Program Review of the Implementation of Approximate Original Contour Regulations in Pennsylvania's Bituminous Surface Mining Program

Harrisburg Field Office

September 2010

Figure 4: This simple illustration depicts the change in hill side morphology for some surface mines in Pennsylvania.

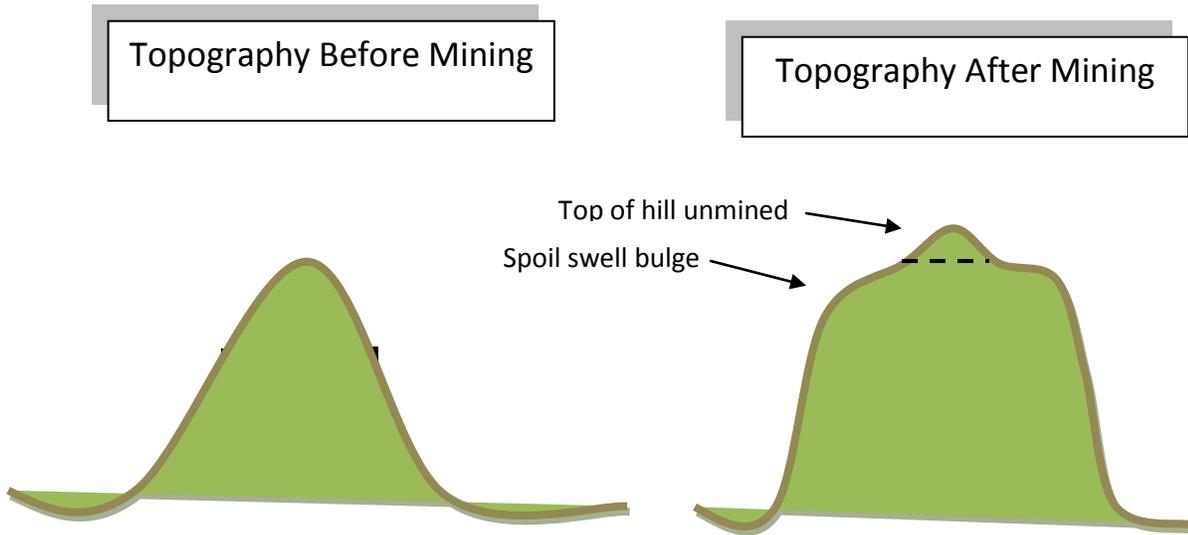
During the study, PADEP personnel were interviewed to identify the largest AOC-related challenge in the bituminous region of Pennsylvania. A reoccurring theme was the challenge presented by spoil swell on some operations. In sandstone-dominated coal measures and sites with large overburden to coal ratios, the spoil swell can significantly increase the pre-mining spoil volume. Adequately blending the spoil swell over the entire mine site can be an inspection and reclamation challenge. Contour and box-cut mining methods are common in Pennsylvania. The nature of these mining methods is to start mining at the outcrop or in low cover areas and progress towards areas of higher cover. Therefore, most of the spoil is piled on the out slopes of the original hillside as the mining pit progresses deeper into the hillside. During reclamation, the equipment operator simply pushes the spoil from the out slope area towards the center of the hill. The equipment operator keeps pushing the spoil until the reclamation surface meets and blends into the top of the highwall. As a result, most of the spoil swell volume is left where it was originally placed, towards the outcrop area on the out slope of the hill side. The concentrated spoil swell creates a “bulge” in the reclamation topography on the side of the hill. The operator is somewhat limited to how the spoil swell is distributed because they must maintain positive drainage on the hill side, they can’t grade spoil in the unmined area above the high wall, and they can’t grade spoil in the unmined area below the low wall. These limiting factors often result in a “bulging” hill side for contour mines in Pennsylvania. The magnitude and extent of the bulge vary with mining and reclamation practices and geology. Figure 4 is an exaggerated depiction of how spoil swell can change the hill side morphology. Photo 1 shows a contour mine during backfilling. The hill side bulge from the spoil swell is noticeable in this photo. Photo 2 shows a depiction of a spoil swell bulge on a site that has achieved Stage 2 bond release. Photo 3 is a close up picture of the bulge in Photo 2. The photo was taken at the bottom of the reclaimed hill side looking up towards the unmined hill top. The bulge from this perspective is more pronounced because the change in slope at the top of the bulge is apparent.

Discussions with DEP staff show that the Pennsylvania program prefers to have the spoil swell “blended” into the reclamation, which results in some variation from the original elevation or morphology, rather than have the excess spoil be disposed of as an “excess spoil” fill in unmined areas or approve a variance from AOC. It is important to note that AOC is commonly achieved with the “spoil swell bulge” incorporated into reclaimed hill sides. The point of this discussion is to highlight one of the few AOC-related challenges in Pennsylvania; the hill side bulge is a relatively minor challenge at limited sites. This issue was one of the few AOC-related issues discussed by PADEP inspectors during this study. Inspectors minimize the shape of the bulge by ensuring operators keep grading more dirt from the spoil pile to the top of the high wall and bottom of the low wall until a relatively even blending/grading is achieved.

Figure 9

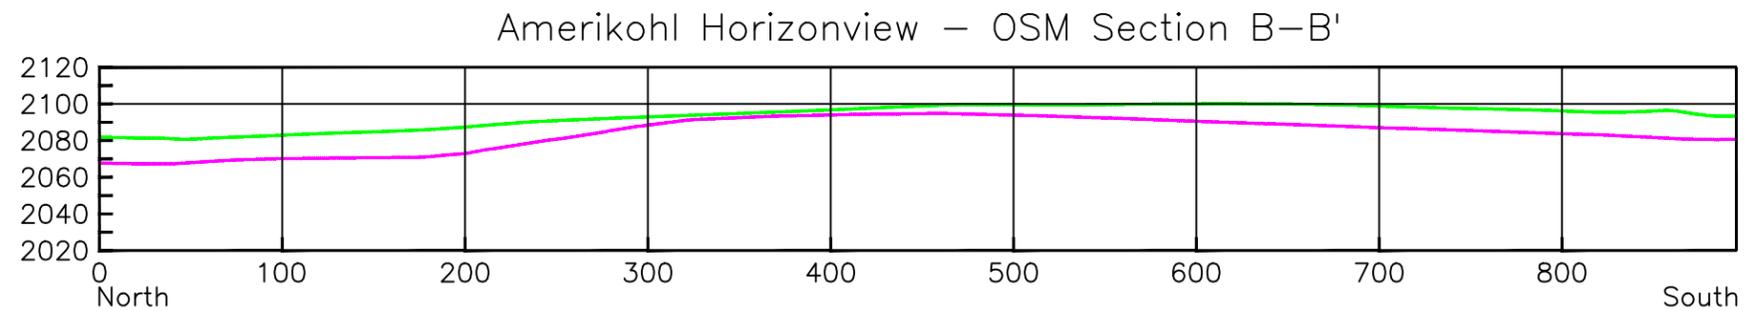
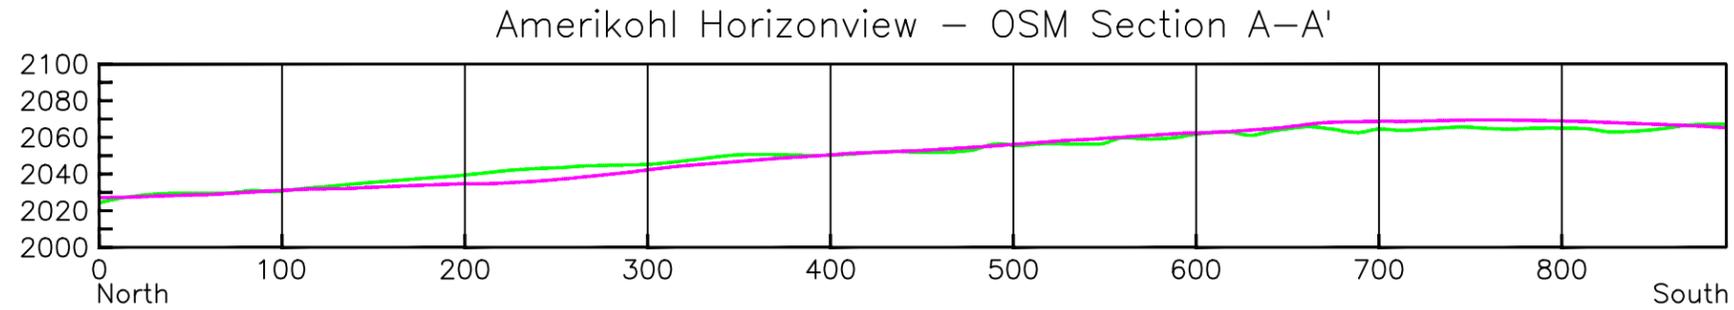
Quantitative AOC Evaluation – Lidar data was used to characterize the pre-mining topography. Remote sensing data was not available to define the post-mining topography. As a result, three GPS transects were performed to collect post-mining elevation data. Figure 9 shows the location of the three GPS transects on the operations map. Figures 10 & 11 are cross sections that show the differences between the pre-mining and post-mining topography along the three transects. Cross section A-A' show

practically no difference in elevation or morphology before and after mining and cross section B-B' show the reclaimed land surface is ~ 20 ft higher in some locations. The last cross section, C-C', shows the reclaimed land surface has a more uniform and consistent slope than the pre-mining topography. The last cross section also showed some areas where the post-mining surface elevation is ~ 20 ft higher than the pre-mining.

Figure 31

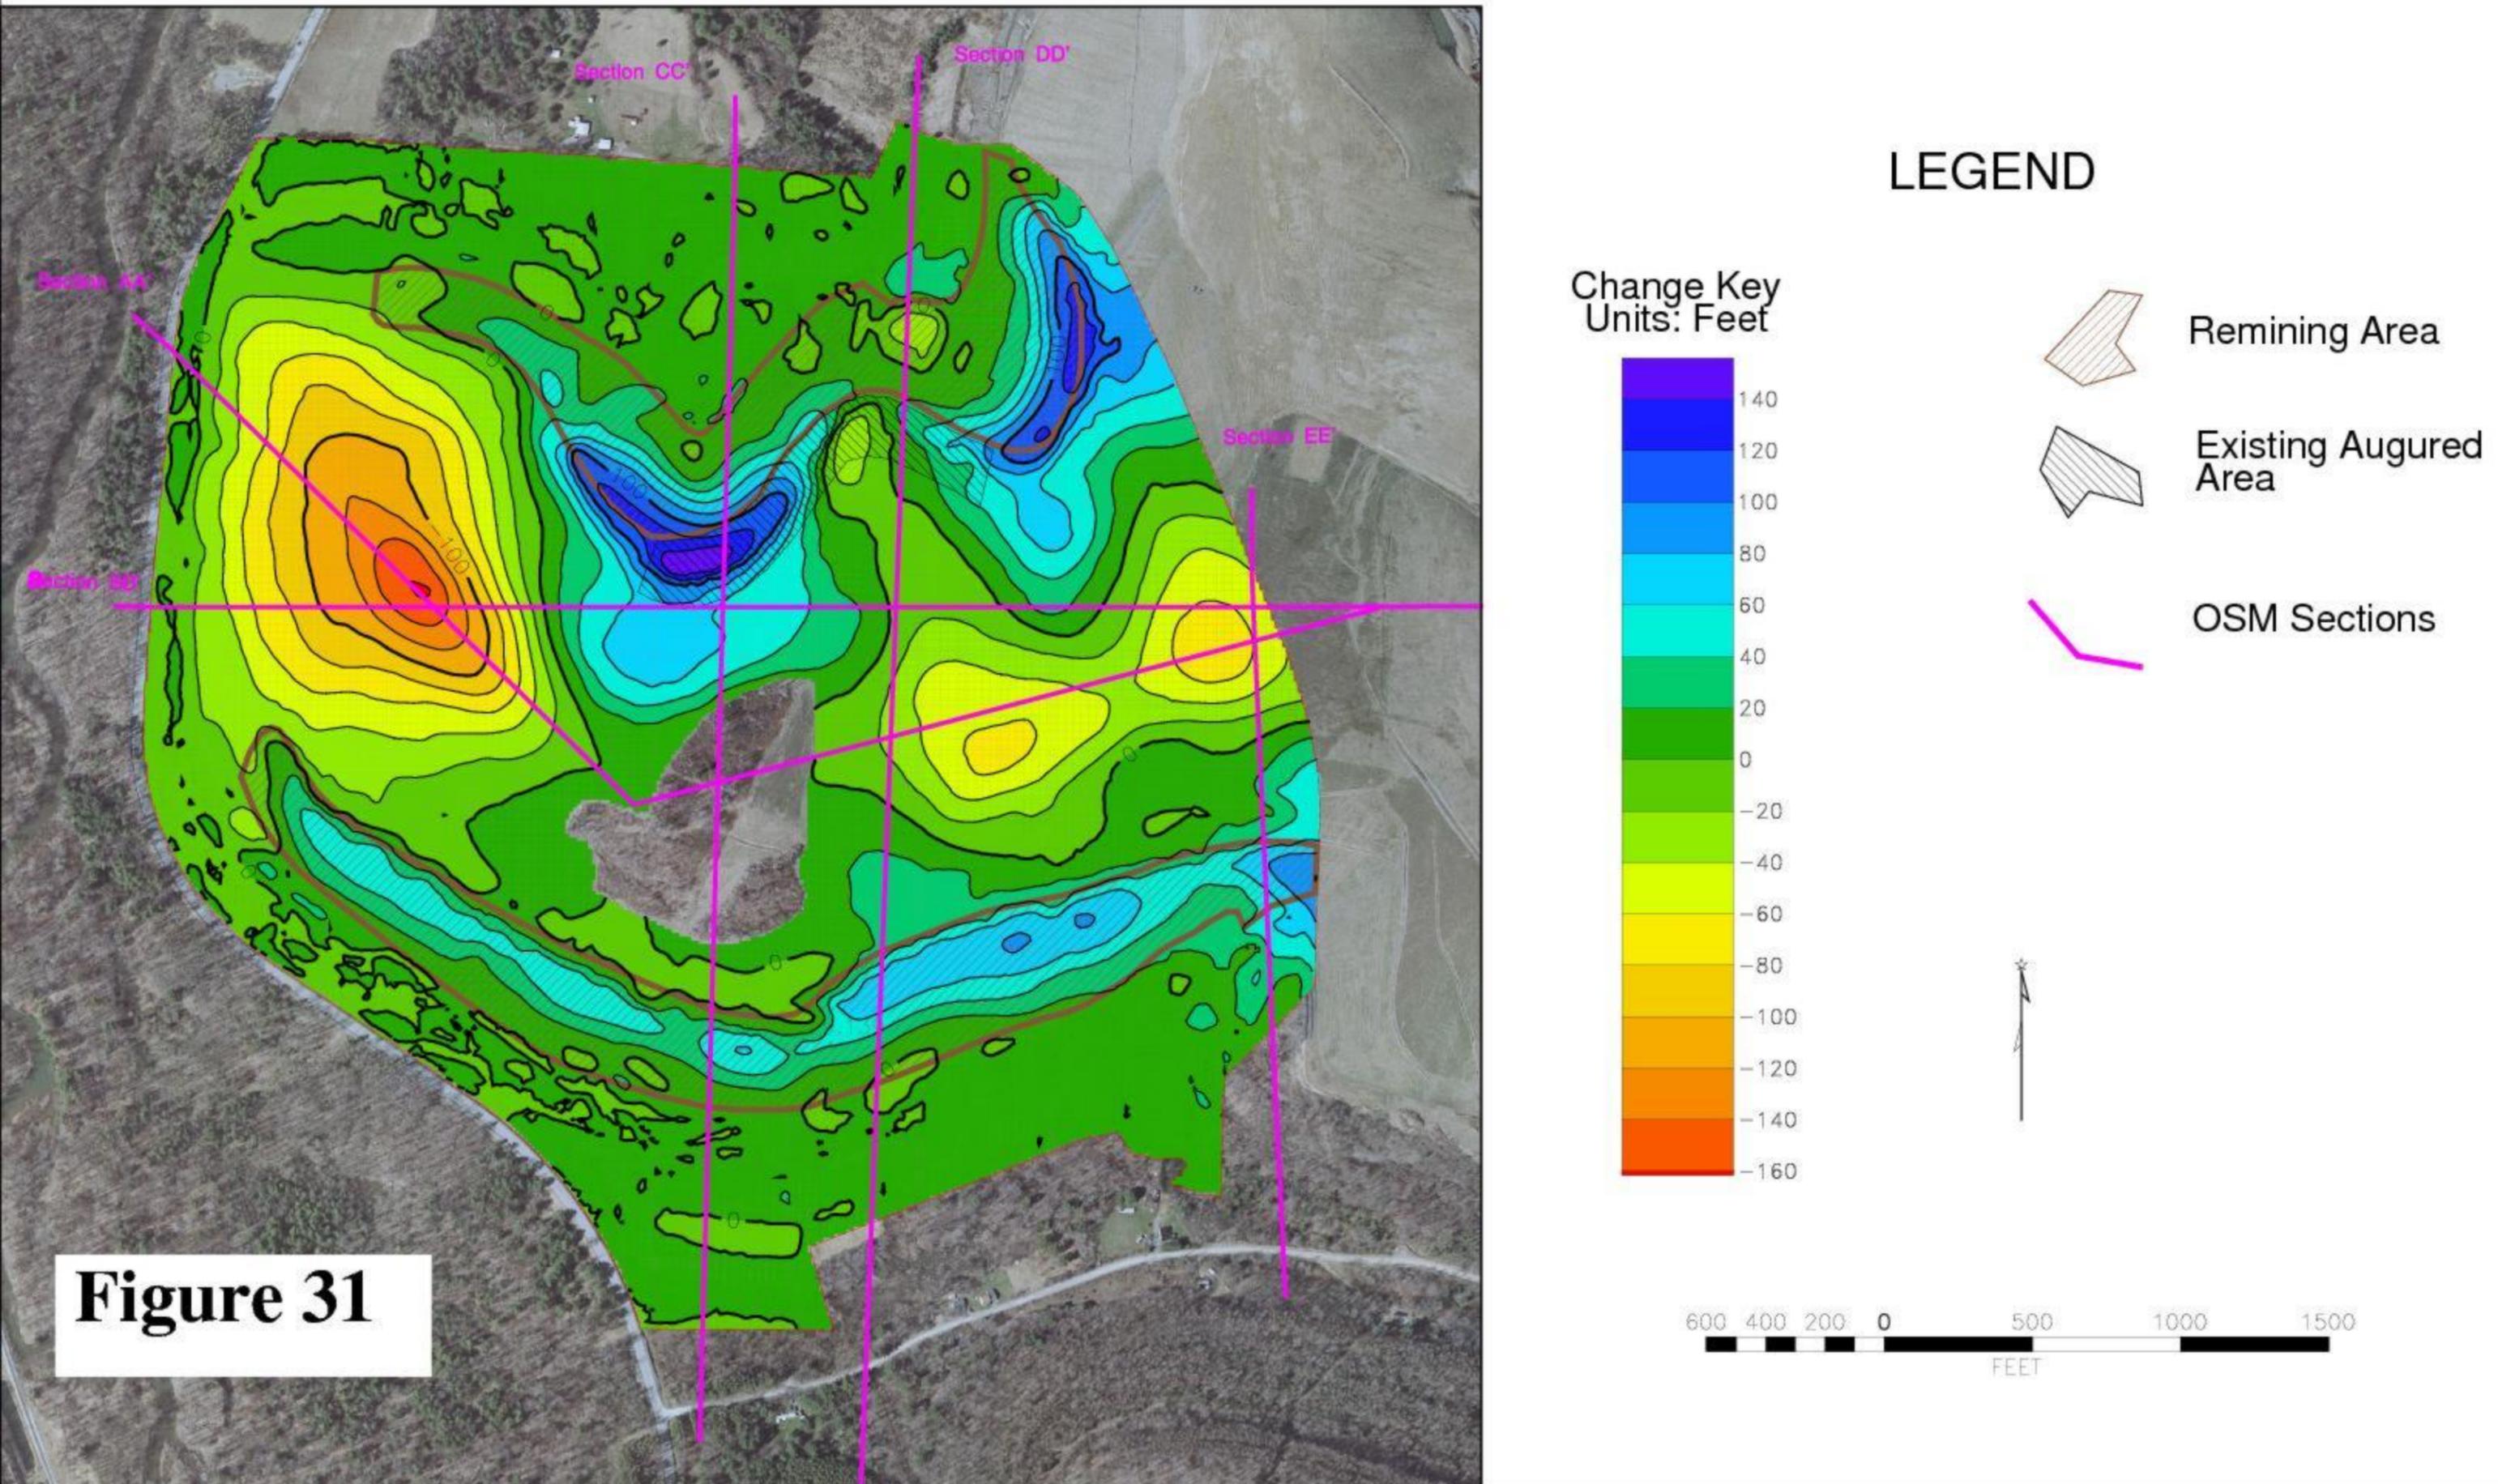
Quantitative AOC Evaluation –An electronic copy of the reclamation map was obtained from M.B. Energy’s consultant and was the basis to generate a pre-mining elevation model. Lidar data was used to characterize the reclamation topography shortly after Stage I was approved. Earth Vision software was used to create elevation models and the pre-mining model is shown in Figure 29 and the post-mining model is shown in Figure 30. Figure 29 shows the site can be characterized as a ridge line with abandoned high walls lining the hill sides. Figure 30 shows that most of the AML features on the remaining permit were eliminated. Earth Vision was used to create an elevation-difference map that quantified the change in the topography (Figure 31). The elevation-difference map was created by subtracting the post-mining elevation model from the pre-mining elevation model. Figure 31 shows changes between the pre mining and post mining topography ranged from 160 ft lower to 160 ft higher. The dark blue areas in Figure 31 represent the remaining areas where the reclamation surface elevation is up to ~140 ft higher than the original surface elevation because the operator was required to fill in abandoned pits to achieve AOC in the remaining areas.. On the other hand, the areas denoted in yellow, orange, and red are areas that are reclaimed to a much lower surface elevation that are not part of the remaining area. The two concentric yellow features located directly west of the unmined hill top represent the lowering of the existing hill tops by approximately 40 ft, which is consistent with the permit. The large concentric orange and red circle to the east of the unmined hill top shows the reclamation lowered the original surface elevation the ridge by approximately 160 ft. Visual examination of Figure 31 shows that most of the reclamation was within +/- 25 ft of the original land surface and the large deviation from the pre-mining topography is relatively constrained to the western side of the permit. The five cross sections, shown in Figures 32 through 36, further substantiated the reclamation topography closely mimicked the pre-mining

elevation in all but the western side of the permit. Figure 37 is a histogram of the elevation-difference data used to create the elevation-difference map in Figure 31. The histogram shows that, of the 1.1 million elevation-difference data points, 25% of the mine site was reclaimed to within 10.5 ft and 75% of the site was reclaimed to within 19.4 ft of the original area. These statistics include the changes in the remaining topography. This analysis shows that a large difference between pre and post-mining elevations is confined to the western portion of the permit where mining last occurred. It's fairly clear that the change in operational plan (less spoil) coupled with the remaining obligation to reclaim the large pits resulted in a spoil deficiency situation in the last mining area. Cross section BB shown in Figure 33 illustrates the issue. The location of cross section BB is shown in Figure 31. In the eastern section of the cross section, the reclamation was very consistent with the approved reclamation plan. The eastern-most hill top was lowered by approximately 40 ft, which is consistent with the approved reclamation plan. However, as the mining plan changed as the mining progressed toward the west, the reclamation surface started to drastically differ from the approved reclamation topography. A revised reclamation plan should have been submitted as the mining operation deviated from the approved mining plan. Therefore, the surface owners still thought the approved reclamation plan was being implemented and never had an opportunity to review or comment on how the change in operations would affect the reclamation of their property. There is no evidence that the property owners or DEP were aware that the surface elevation would be lowered by 160 ft in the western part of the permit. With that said, there were no objections to Stage I bond release and DEP concluded the site achieved AOC. Moreover, the OSM site inspection used the same field techniques as the DEP inspectors to evaluate AOC. The OSM site inspection was completed before any knowledge of the results of the quantitative analysis. OSM performed a visual comparison of the reclamation map to the site reclamation and noted differences between the two but did not identify the lowering of the western-most hill top by 160 ft. The permit stated that the western-most slope would be reduced to a gentler grade, but the lowering of the hill top was not obvious in the field. A visual observation of the reclaimed land surface shown in Figure 30 shows a "natural-looking" land surface and the loss of 160 ft in elevation in the western portion of the permit is not obvious without close examination. The reclamation blended into the surrounding topography and without a point of known elevation to reference, the reduction in elevation was not apparent in the field. There are very few ridge mines in the bituminous region of Pennsylvania. Most mining operations are contour strip or box cut. Achieving AOC is much easier with those mining methods as the operator is likely to achieve AOC by just regrading to the original unmined ground at the top of the high wall and the bottom of the low wall. Achieving AOC in a ridge operation is more difficult. If the entire ridge is mined, there are no unmined areas left on top of the hill that can be used as a point of reclamation reference. Since DEP's current definition for AOC only includes qualitative metrics, neither

- The original mining plan changed which affected the implementation of the approved reclamation plan;
- The mining company failed to follow the approved reclamation plan;
- The mining company did not submit a revised reclamation plan nor did DEP require a permit revision as the operational plan changed;
- DEP concluded the site achieved AOC during the State I inspection;
- OSM's field inspection noticed the site reclamation deviated from the approved reclamation plan;
- The OSM field inspection concluded the site achieved AOC;
- Quantitative analysis showed a hill top in the western side of the permit was lowered by 160 ft, however, the analysis showed the majority of the site was reclaimed to

- within +/- 20 ft of the original land surface;
- The lowered hill top area was ~ 30 acres of the 258 acre permit
 - There is no evidence that the land owners or DEP were aware that the reclamation would significantly alter from the approved reclamation plan in the western portion of the permit;

- OSM concludes the lowering of the hill top is a result of a change in the mining plan, which resulted in less spoil being available to complete the approved reclamation plan as the mining progressed westward;

- A permit revision should have been required to identify the change in reclamation topography. A revision to the reclamation plan would have afforded DEP with the opportunity to ensure the new reclamation plan is consistent with their interpretation of AOC and the post-mining land use and would have allowed the land owner to evaluate and comment on the change.

Figure 32

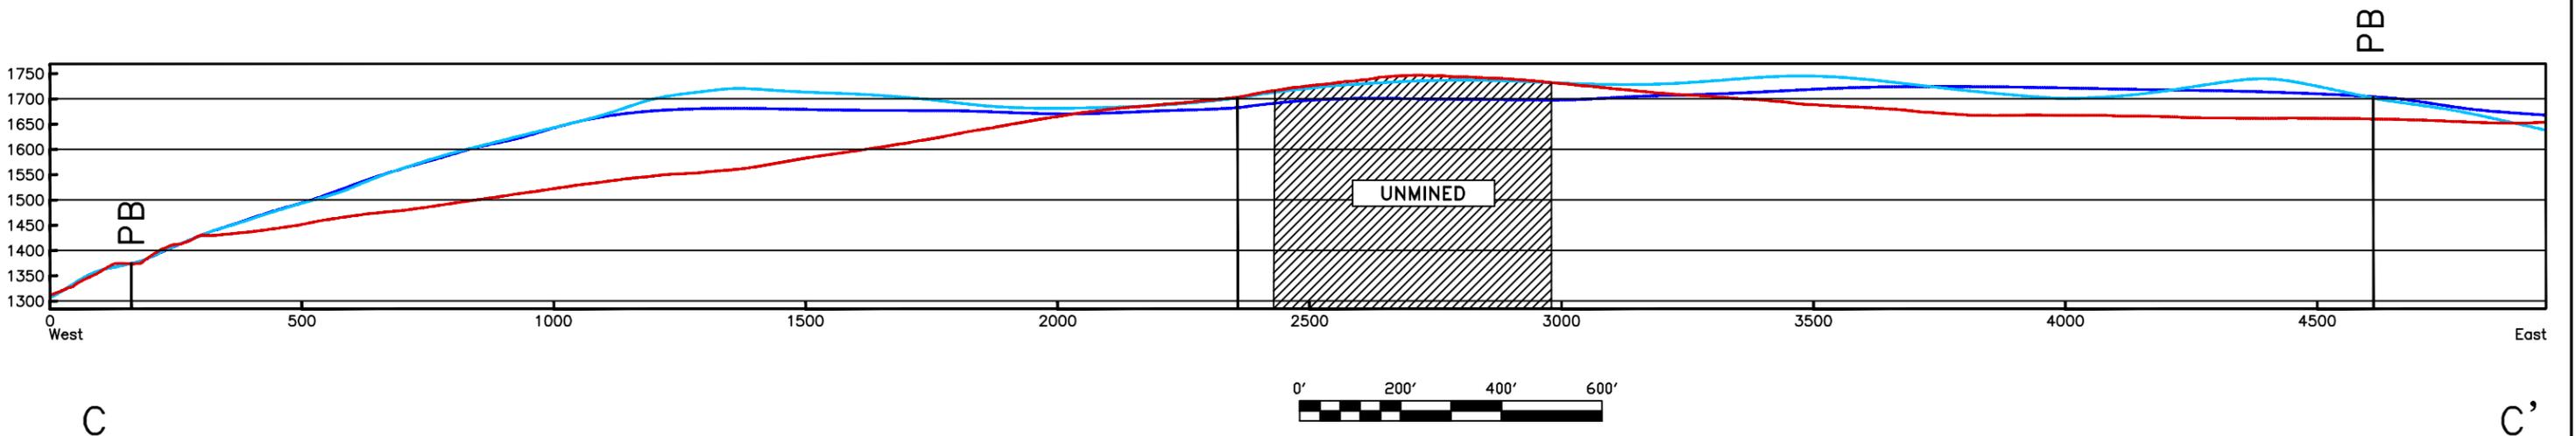
Hill top lowered by 160 ft

OSM Cross-section B-B'

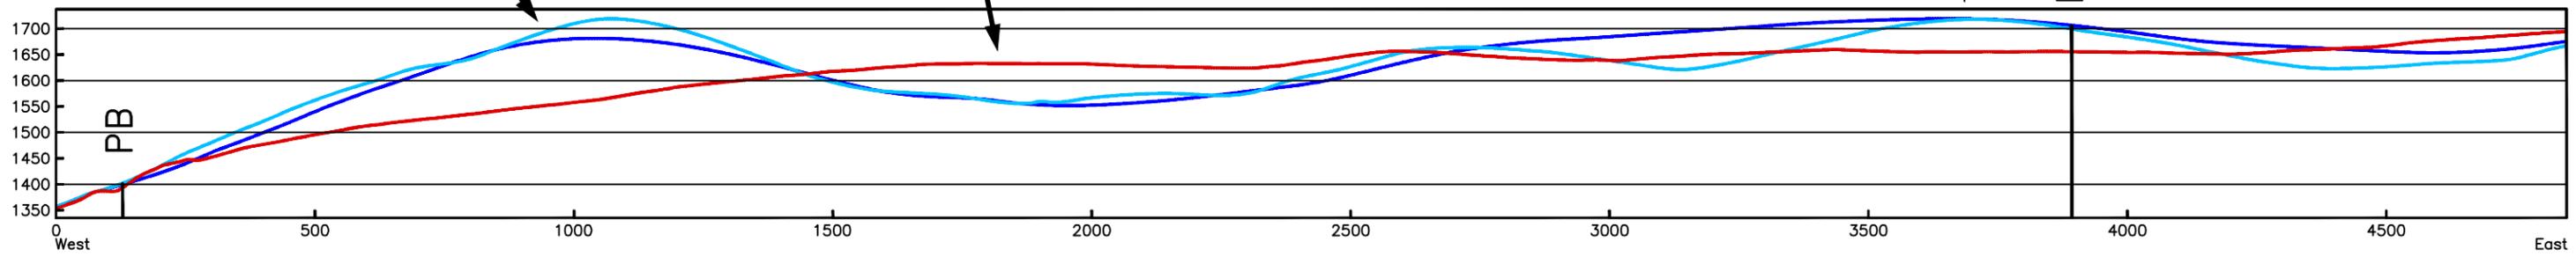
AML pit reclaimed

Hill top lowered by ~ 40 ft like permit stated
